# ITEM #5 - PRELIMINARY PLAT Rappe Park Oliva Addition

KPB File No.	2023-114
Plat Committee Meeting:	December 11, 2023
Applicant / Owner:	Louis and Stacy Oliva of Nikiski, Alaska
Surveyor:	James Hall / McLane Consulting Inc
General Location:	Park Road and Sara Jane Street, Nikiski, Nikiski APC

#### STAFF REPORT

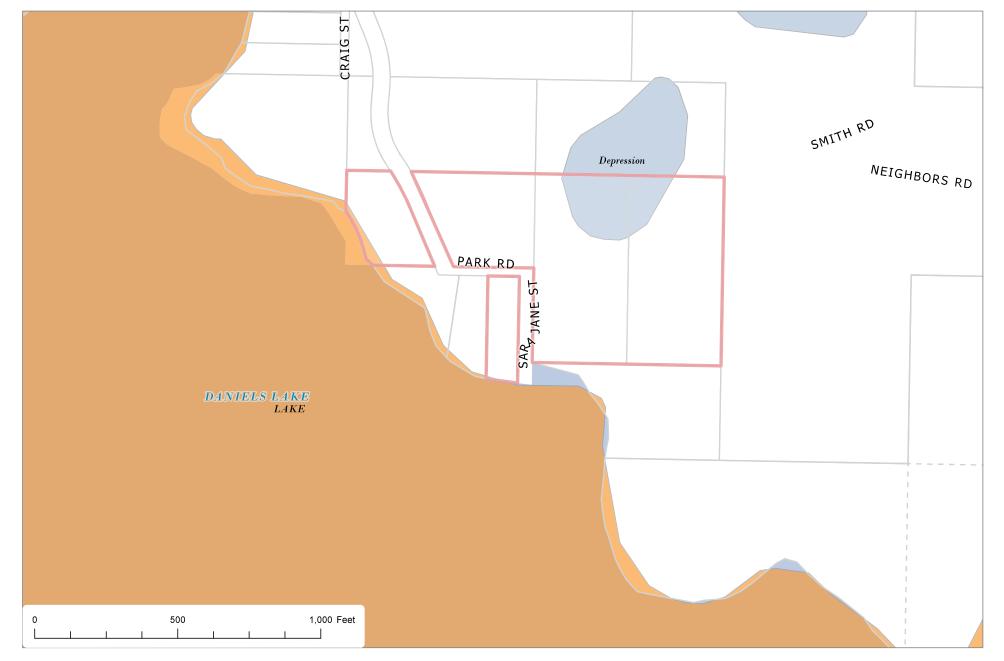
Change the KPB File no to 2023-114

Add to the owners Triple Crown Land & Livestock LLC and address, listed as owners of Lot 1 Rapper Park. Change A. in Stacy A. Oliva to Ann as shown on the KPB Assessing page for ownership.

Add Gov't Lot 37 to the legal description.

Show the patent easements #1234325 in Gov't Lot 19.

Show the patent easement #1233765 in R/W of Sara Jane Street as not being vacated with this plat or vacation process.

Include dimension data of the ASLS of Park Rd along the side of ROW

Reduce the scale for better visibility and add some street names.

Fix the overstrike of Daniels Lake.

Make Kenai Spur Highway closer to the subject plat.

Correct the area of Lot 17-A, includes the dedicated right-of-wat and ASLS areas.

Add a lot on the west side of Park Rd.

Make the lines around dedication solid Add dimensions to the dedications.

Add the area to the east dedication.

Need to add lot on west side of Park Rd.

Areas of grade over 20% need shown

No street names given. Get with KPB Addressing for approved names.

Need bearings and distances on existing Park Rd and new dedications

Add behind the names on the signature lines under the Certificate of Ownership, the lots signing for. Add behind Stacy A. Oliva on the signature line of the Certificate of Ownership 'aka Stacy Ann Oliva' Add the date of December 11, 2023 to the Plat Approval.

Add a Certificate of Acceptance

Show base bearing.
